The University of Mississippi Medical Center
2500 N State Street
Jackson, MS 39216

Project Name: UMMC Proj# 2606018 | Robbie Hughes Playground
Project Number: 23-057

ADDENDUM NO. 2

C2.1
GRADING & DRAINAGE
PLAN

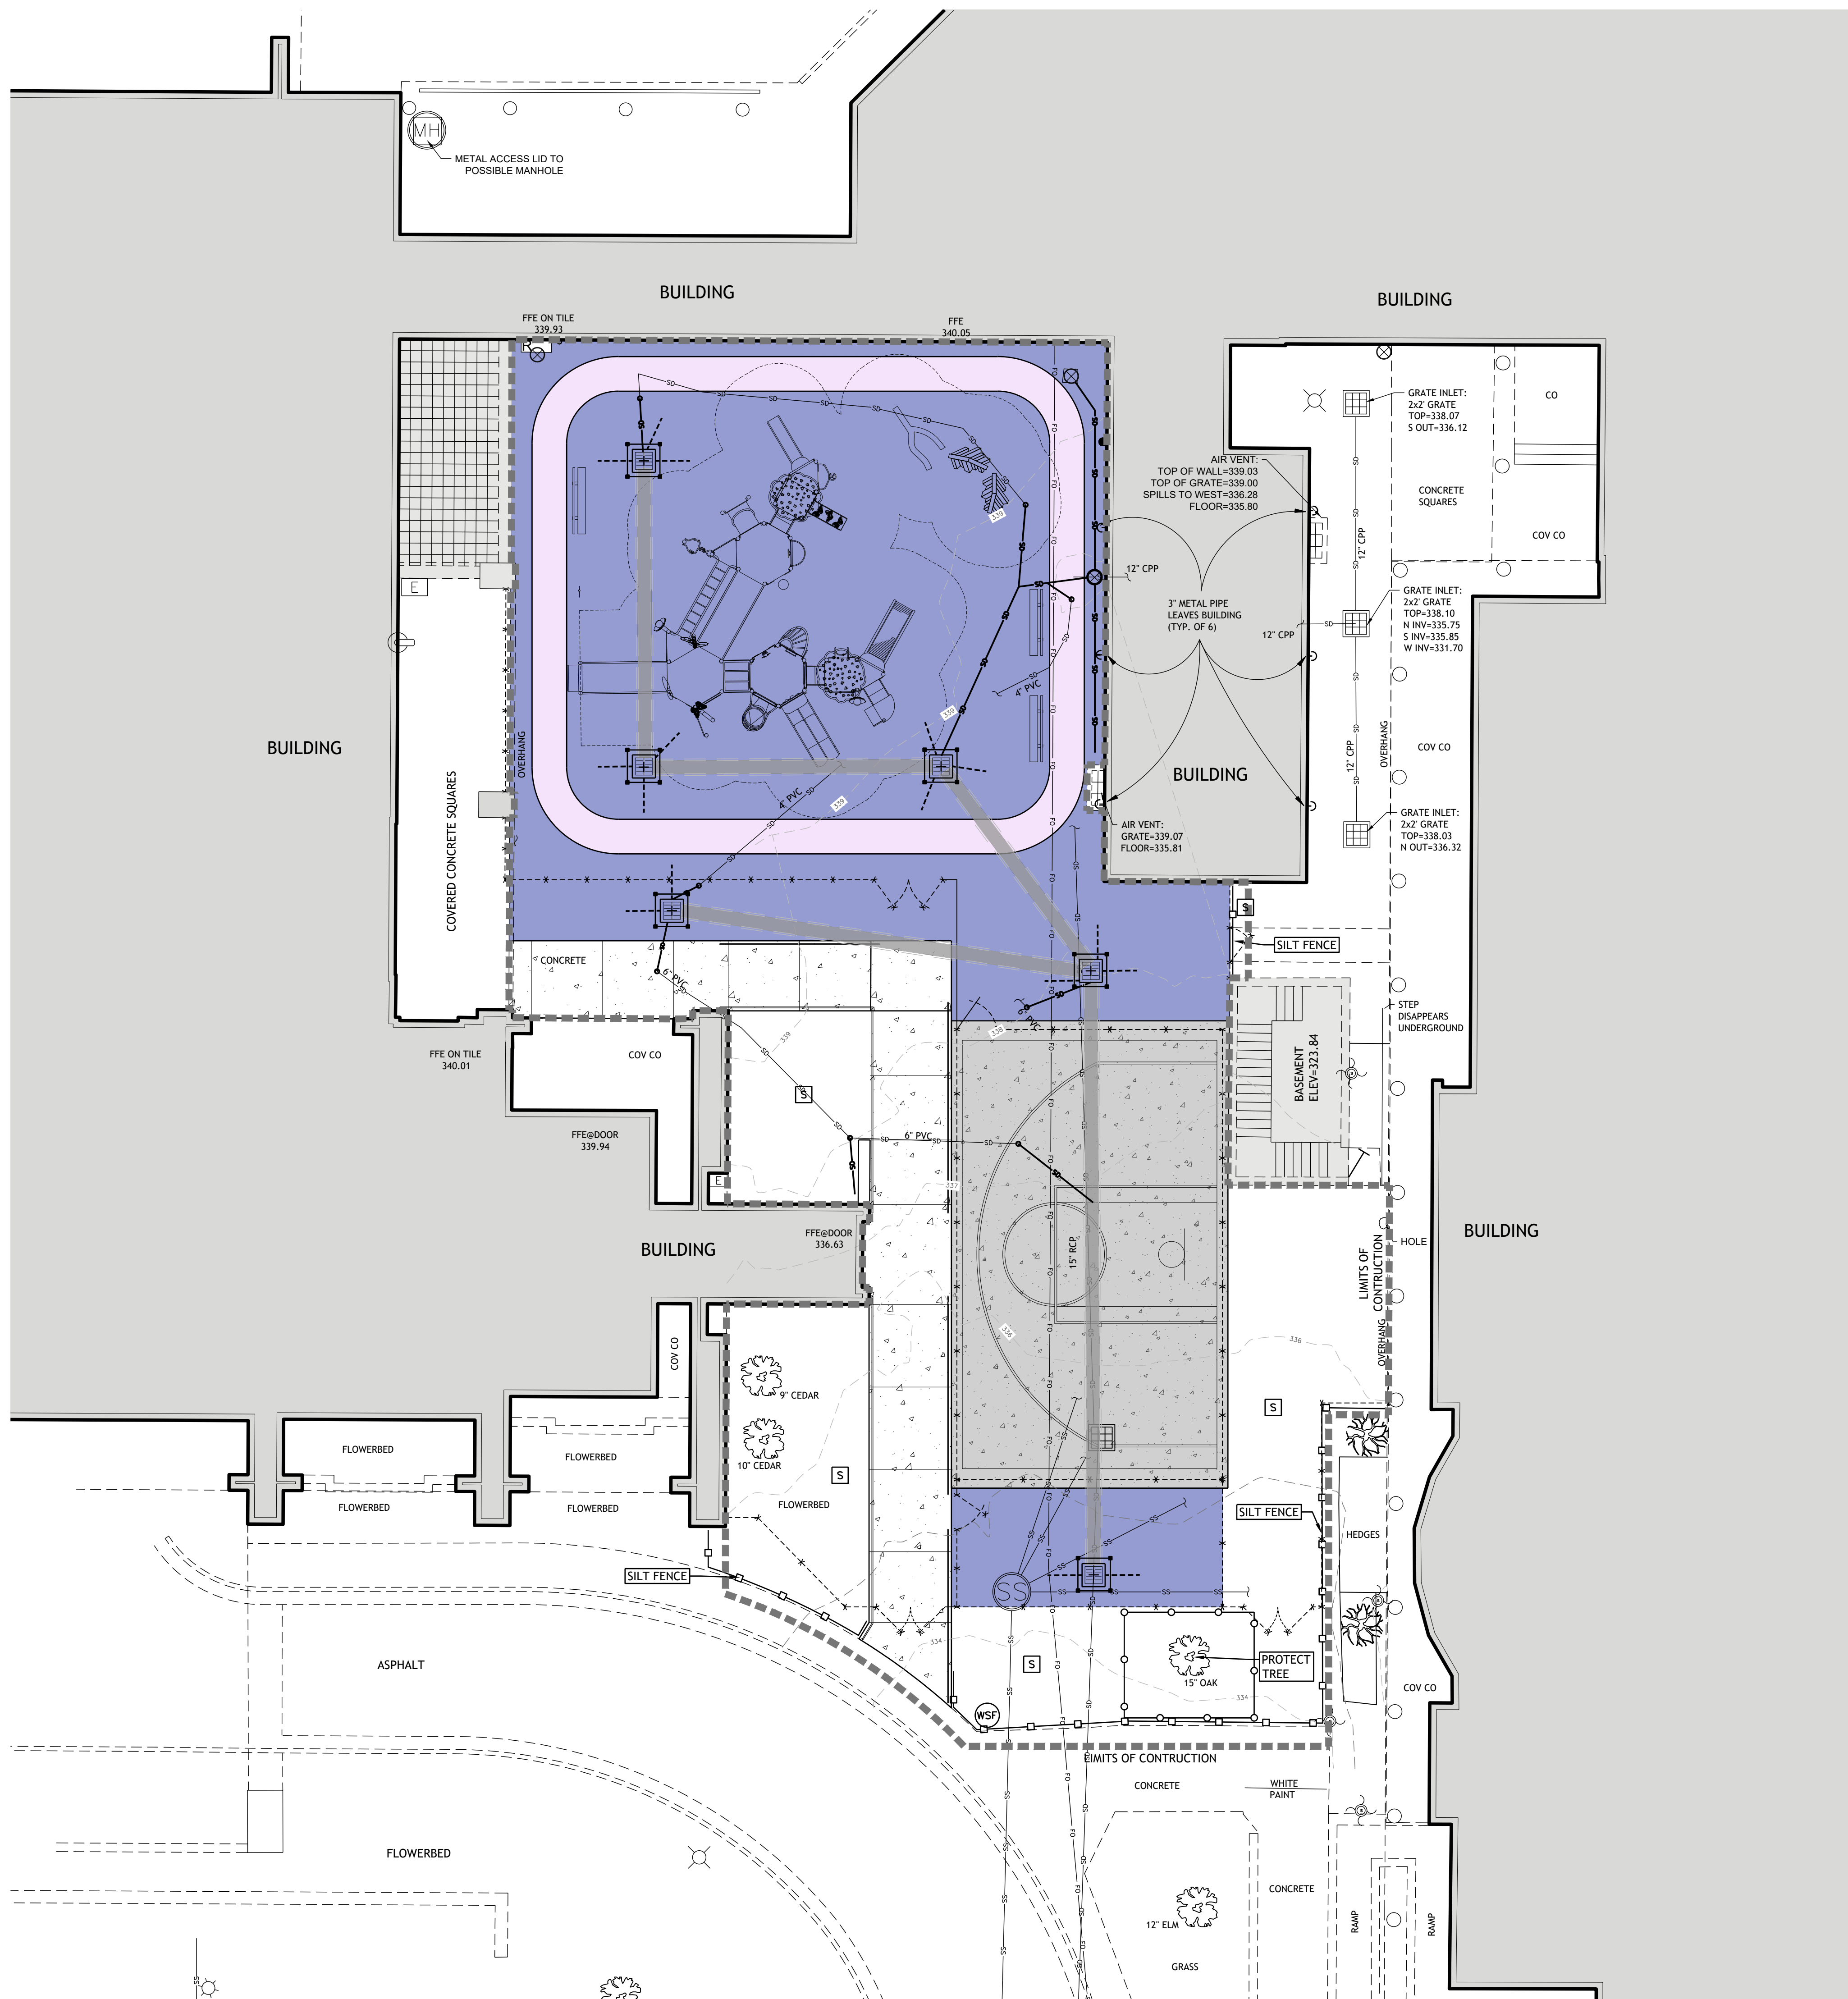
- ITEM NO. 13 **C0.1 - GENERAL NOTES**
REPLACE the attached C0.1
REVISES construction fence height from 4ft to 6ft
- ITEM NO. 14 **C0.2 - EXISTING CONDITIONS / DEMOLITION**
REPLACE the attached C0.2
REVISES existing survey with additional data from utility locate.
REVISES limits of construction
ADDS note #11
ADDS scope: During pre-bid site visit, an eroded hole was discovered. This hole shall be filled during construction.
- ITEM NO. 15 **C1.0 - SITE PLAN**
REPLACE the attached C1.0
REVISES site plan
- ITEM NO. 16 **C2.0 - SPOT ELEVATION**
REPLACE the attached C2.0
REVISES spot elevations plan
- ITEM NO. 17 **C2.1 - GRADING AND DRAINAGE PLAN**

REPLACE the attached C2.1

ADD additional area inlet and reroute piping to avoid the playground footings

ADD multiple +/- 6ft sections of 4" perforated Sch. 40 PVC pipe under the turf to drain aggregate base to the nearest inlets

REVISES limits of construction

8 SINGLE PRECAST AREA INLET DETAIL

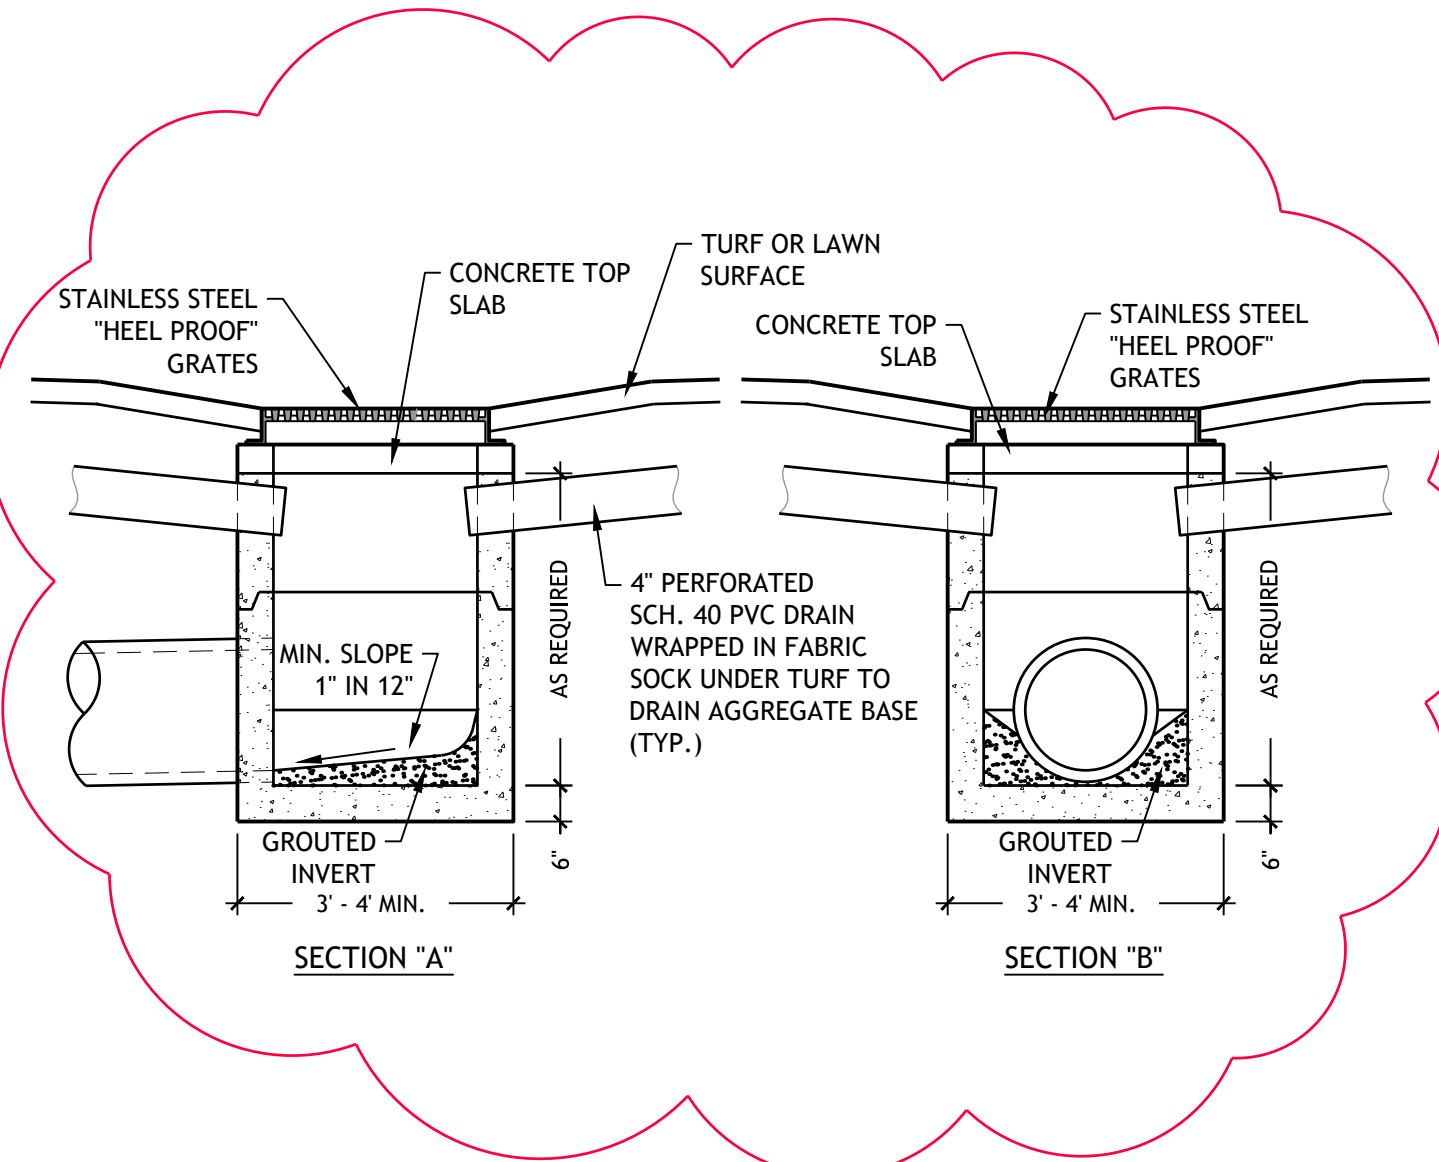
ITEM NO. 19 **C4.0 - MISCELLANEOUS DETAILS**

REPLACE the attached C4.0

ADDS single precast area inlet detail

1 CONSTRUCTION FENCING

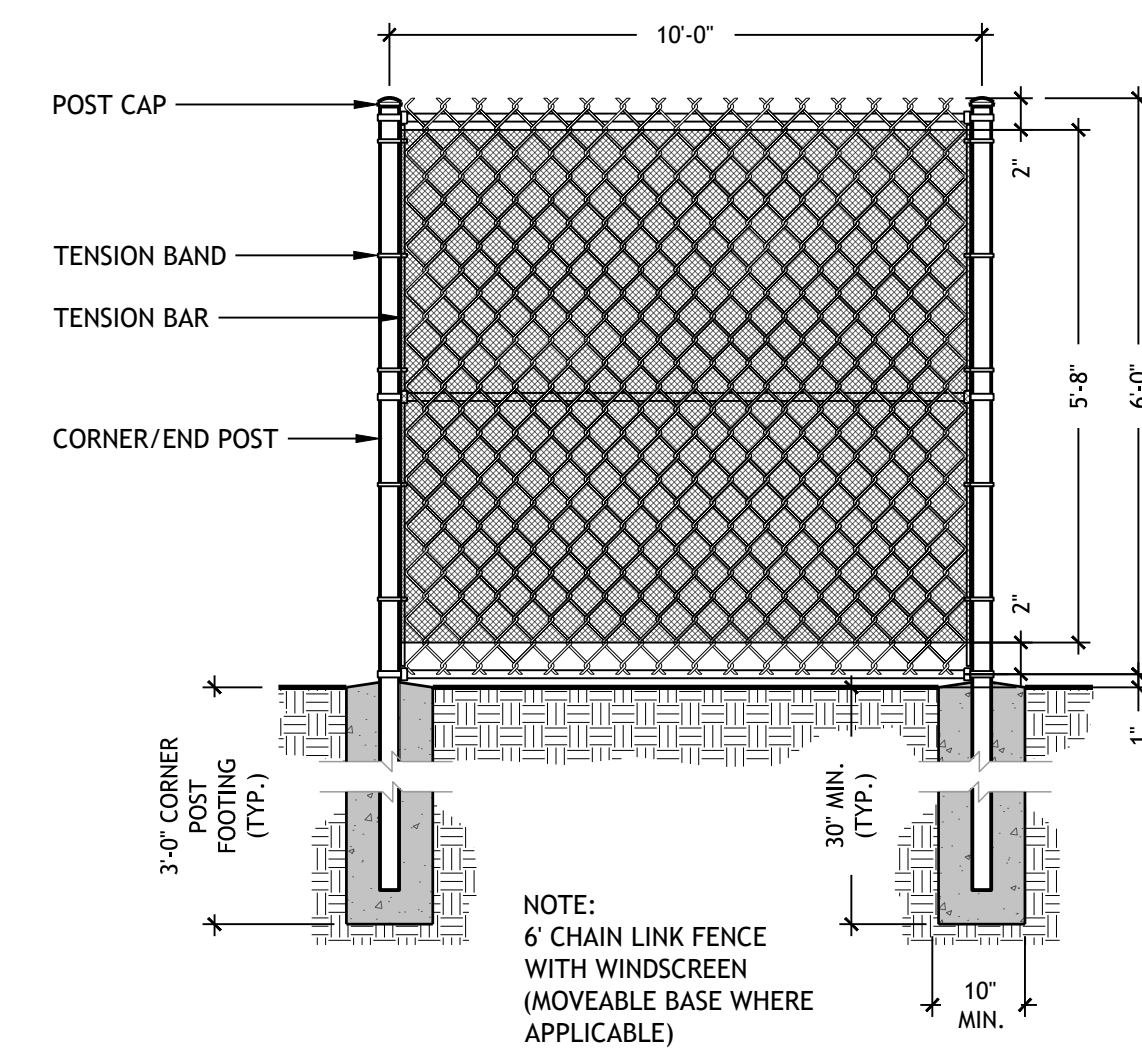
ITEM NO. 5 **CONSTRUCTION FENCING**
The Contractor shall install a chain link construction fence at least 6-foot tall around the site along the construction limits shown on the plans. The fence shall include black privacy fabric or black privacy slats.
